GARDNER CREEK DAM

NDS ID NO. PA-00575

PHASE I INSPECTION REPORT

NATIONAL DAM INSPECTION PROGRAM

A. Embankment Looking from
Right Abutment

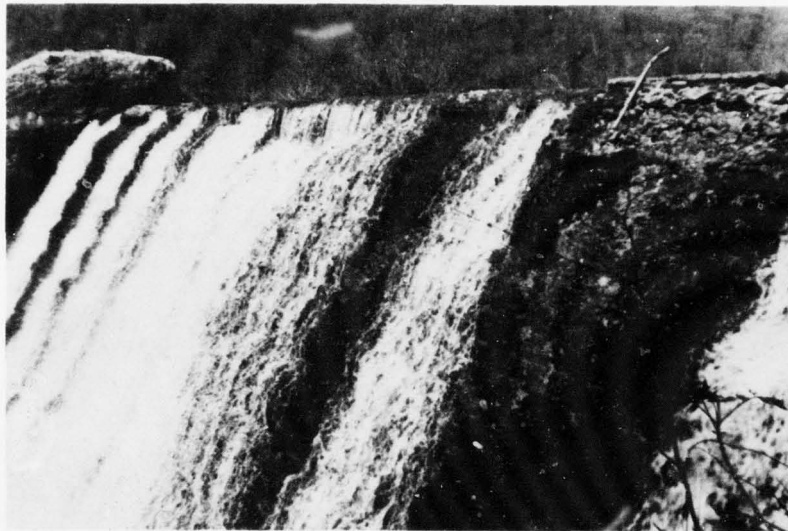
(2) The upstream slope of the embankment was adequately maintained except that some light brush was growing near the water level (Photograph A). Riprap was intact and continuous except for a 30-foot reach adjacent to the right side of the spillway (Photograph H).

(3) The downstream slope of the embankment had a uniform slope and was adequately maintained. (Photographs A and B). The vegetation consisted of a light growth of weeds and very small shrubs. The type and extent of the vegetation indicated a rather fragile environment. There appeared to be very little topsoil available to support development of sod. Vegetation on the downstream slope had been cut recently. A path was worn or excavated on the downstream slope near the right abutment to a maximum depth of 2 feet. One hole caused by a burrowing animal was located near the center of the dam about 10 feet above the toe. Signs of recent burrowing were observed.

(1) Remove brush growing on upstream slope of embankment and in spillway approach area.

- (2) Replace missing riprap near spillway.
- (3) Repair bare path on downstream slope of embankment.
- (4) Fill hole on downstream slope of embankment caused by burrowing animal.

E. Disintegration, Large Crack, and Displacement of Spillway Left Wall

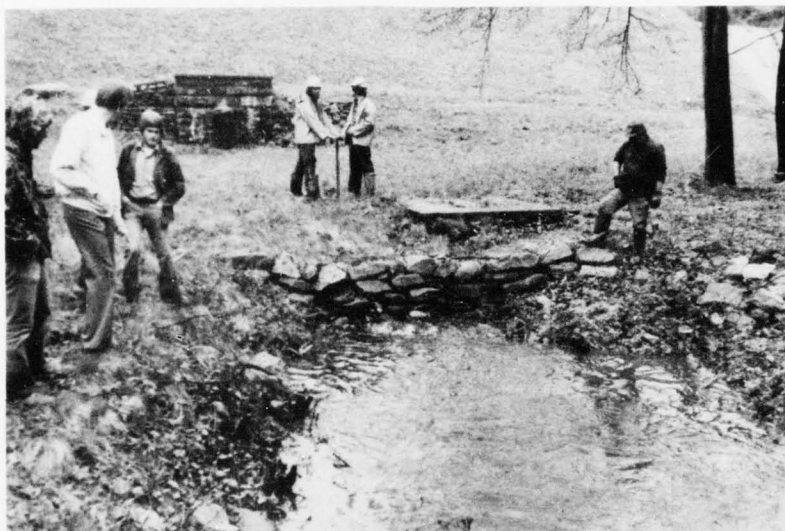
(5) The left spillway wall had severe disintegration over about 80 percent of its exposed face (Photographs E and F). The worst area was a about mid-height near the toe of the spillway (Photograph E). At that location, the estimated depth of disintegration was 2 feet. An average depth of disintegration for the wall could not be determined. A 70-foot long crack, predominantly horizontal and located about 4 feet above the channel bottom, begins near the downstream end of the wall and extends upstream into the area of most severe disintegration (Photographs E and F). The portion of the wall above the crack was overhanging the lower portion by an average of 0.35 foot.

(2) The overall condition of the spillway and the spillway walls are generally unsatisfactory. Review of previous inspection reports indicates that deterioration of the concrete began at least as early as 1919. Repairs were made to the exposed faces of the spillway walls in 1930, but the present condition of the walls is poor. The deterioration of the concrete on the spillway and the right wall does not appear to be so extensive as to seriously endanger the structures at present. However, the left spillway wall has deteriorated to the extent that its structural integrity is questionable. A study of the condition of the spillway was made by the Scranton-Spring Brook Water Service Company in 1950. At that time, the horizontal crack and differential movement had already occurred. Drawings from the files of

the Owner indicate an average movement at that time of 0.16 foot. The present average displacement is 0.35 foot. This increase in displacement, coupled with areas of disintegration to depths of about 2 feet, indicates a potentially serious condition. If this wall failed, a slide of the adjacent hillside would probably also occur. It could not be determined from the visual inspection whether a failure of the wall would seriously endanger the dam and the spillway. The effects of failure would depend on extent of failure, amount of sliding of the hillside, and pool level at time of failure. It is sufficient to say that every effort should be made to avoid a failure of the wall.

- (3) Monitor differential movement of left spillway wall at regular intervals.
